Appendix E  
Correspondence

*Re: Pre-Application Meeting*  
*Silo Ridge Resort Community – Traditional Neighborhood Alternative*  
*Town of Amenia, Dutchess County, New York*  
*TCC Job #: 10454.02*

Silo Ridge Resort Community  
Traditional Neighborhood Alternative  
**OVERALL WETLAND IMPACT MAP**  
Town of Amenia, Dutchess County, New York

**Figure  
5-10**

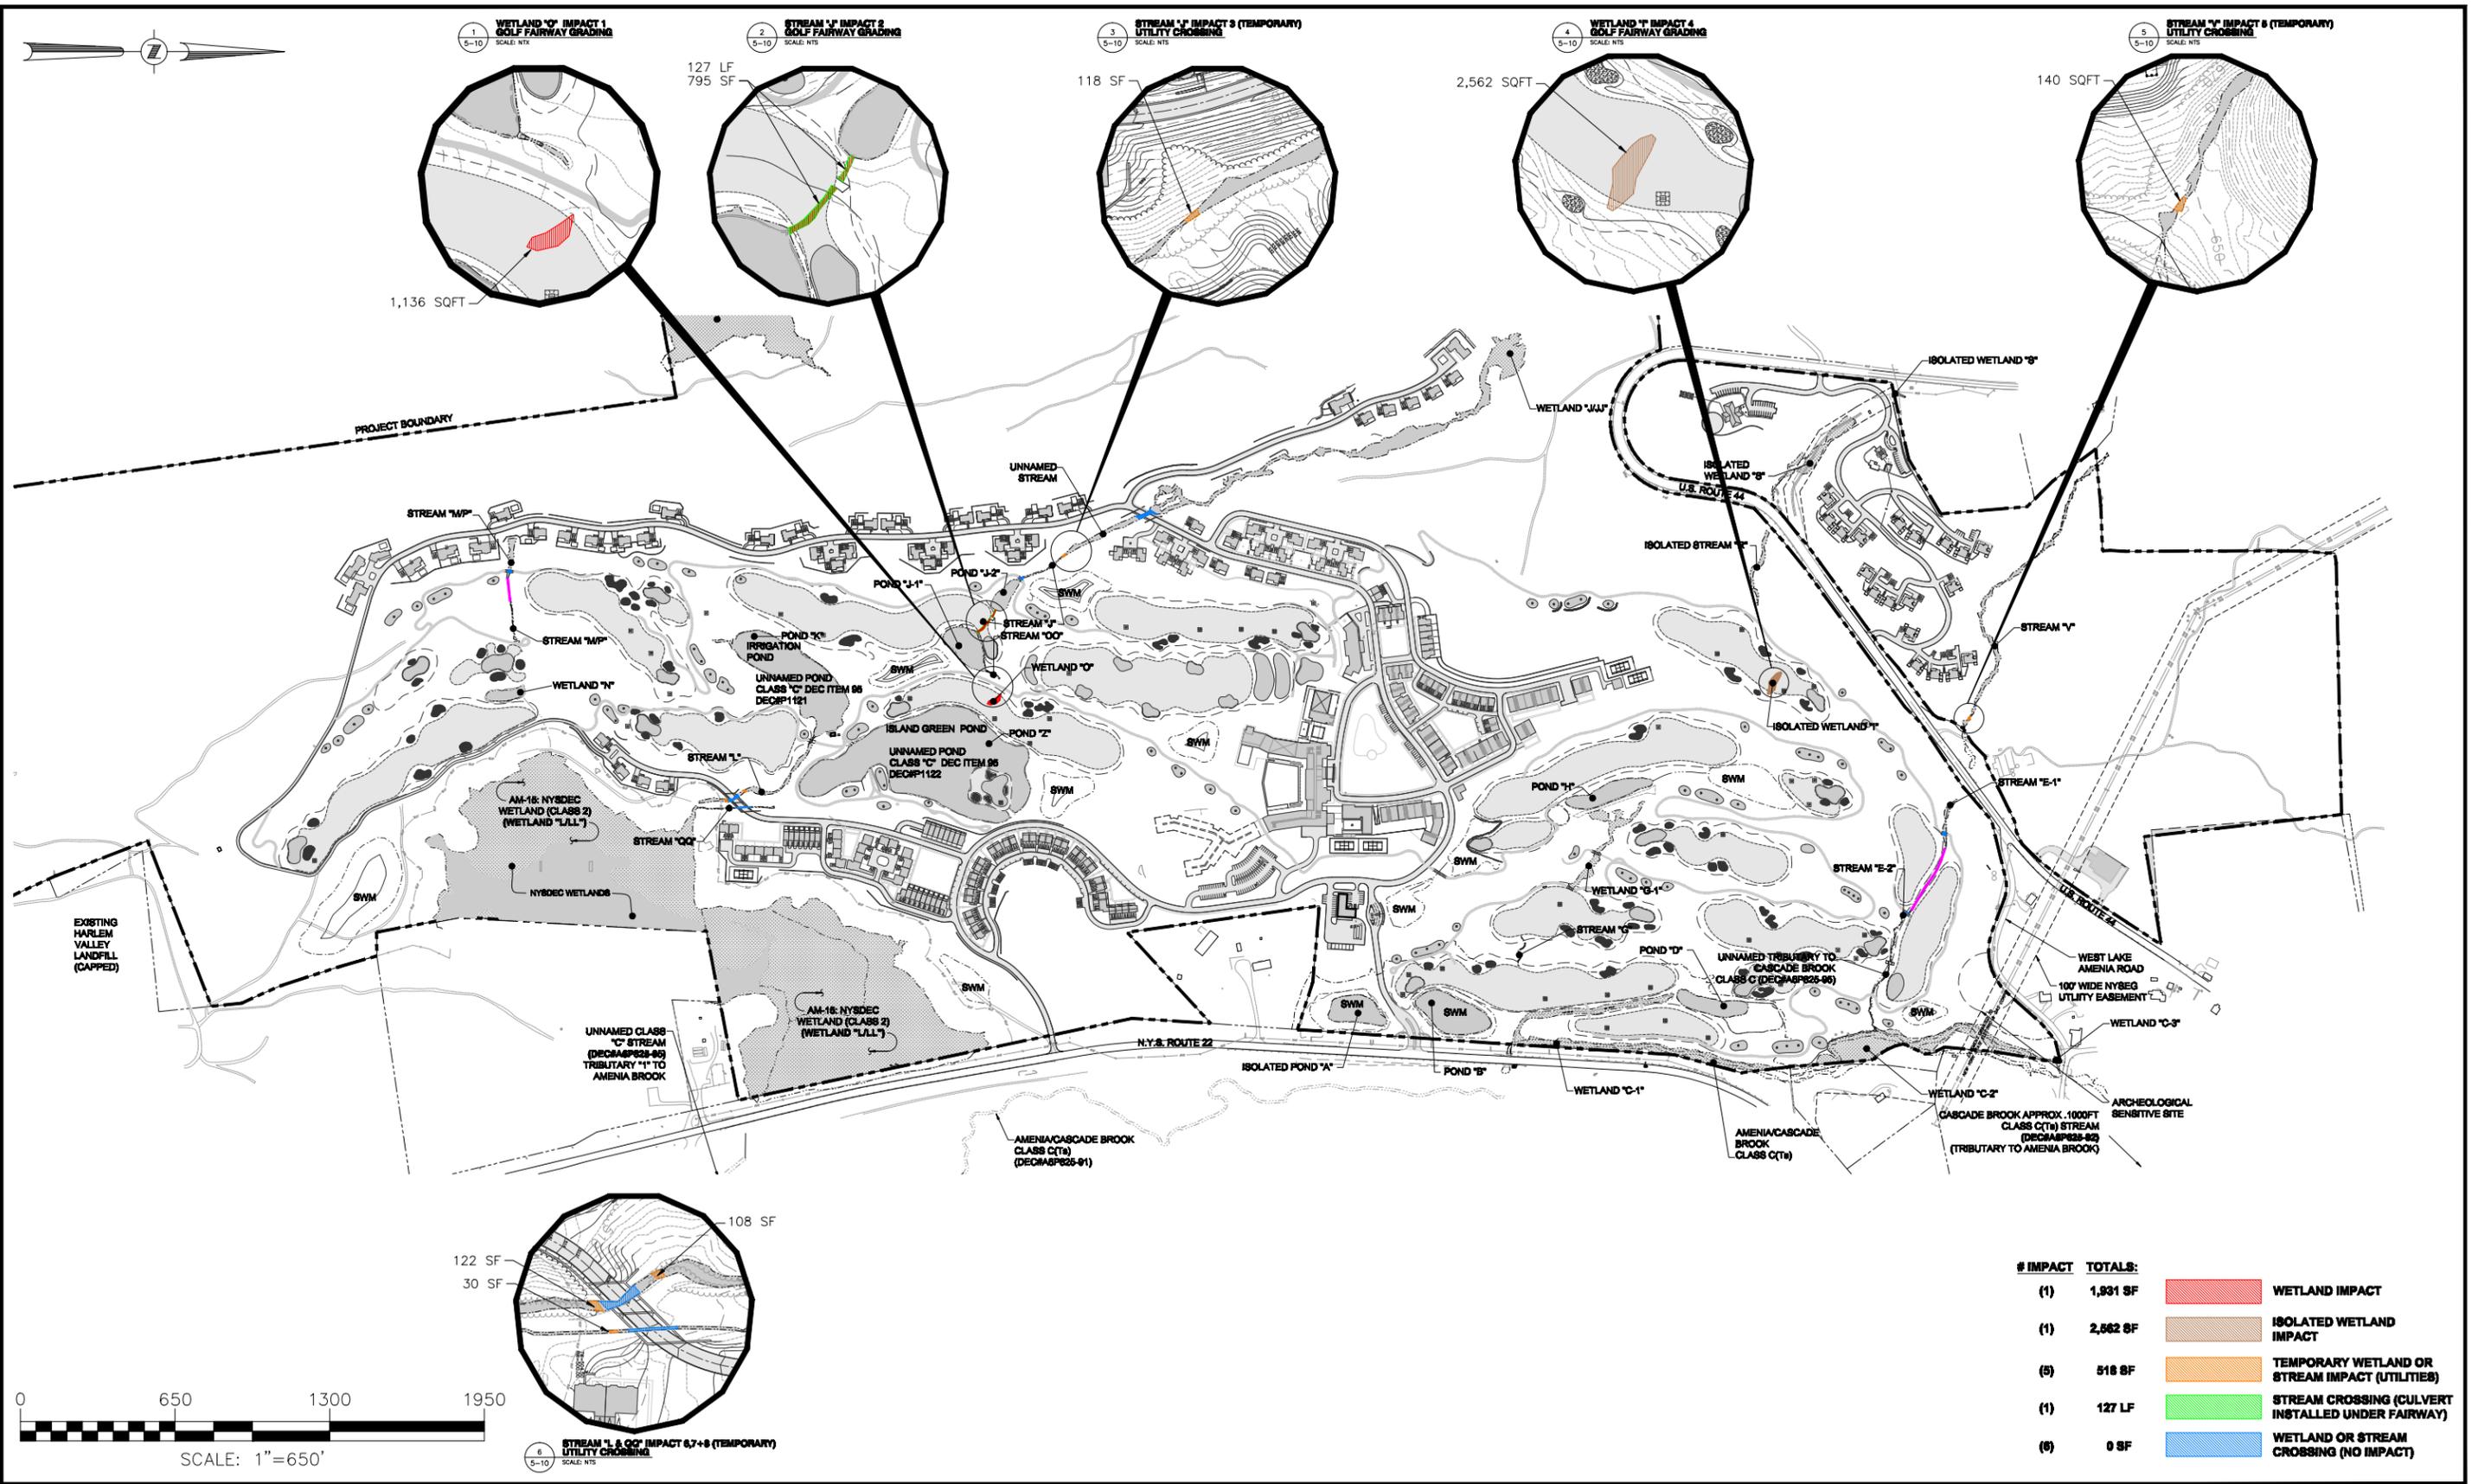
*Federal:* Overall Wetland Impact Map (Figure 5-10) illustrates the impacts to federally regulated waters and wetlands on the site. The following direct impacts to federal wetlands are proposed for the project:

- Wetland O. This will involve impacts to 1,136 square feet (0.03 acre) of wetlands for golf course fairway grading. (See Figure 5-10, Detail 1).
- Stream J. This 127 linear feet of stream disturbance impact (795 square feet or 0.003 acre) is associated with grading of the 17<sup>th</sup> fairway (See Figure 5-10, Detail 2). This impact was discussed with the golf course architect; the impact cannot be avoided due to the need for a landing area in front of the green.

- Stream J. This is a temporary impacts associated with utility line crossing of wetlands and waters, and will be approximately 118 square feet in size. (See Figure 5-10, Detail 3). This impact area will be completely restored.

- Wetland V. This is also a temporary impact associated with a utility line crossing of wetlands and waters, and will be approximately 140 square feet in size. (See Figure 5-10, Detail 5). This impact area will be completely restored.

- Wetland I. This impact involves 2,562 square feet for golf course fairway grading. Since this is an isolated wetland, this is technically not a regulated impact. (See Figure 5-10, Detail 4).

- Stream L & QQ. This involves cart path crossings, discussed below and three temporary utility crossings of wetlands and waters, at 122, 108 and 30 square feet, respectively. (See Figure 5-10, Detail 6). This impact area will be completely restored.

In theory, it's a good idea to add the wetland area around the existing ponds. I would still want to see the actual grading plans to make sure that you would not be grading into the existing ponds. Grading into the existing jurisdictional waters would need to be included in any impact calculations.
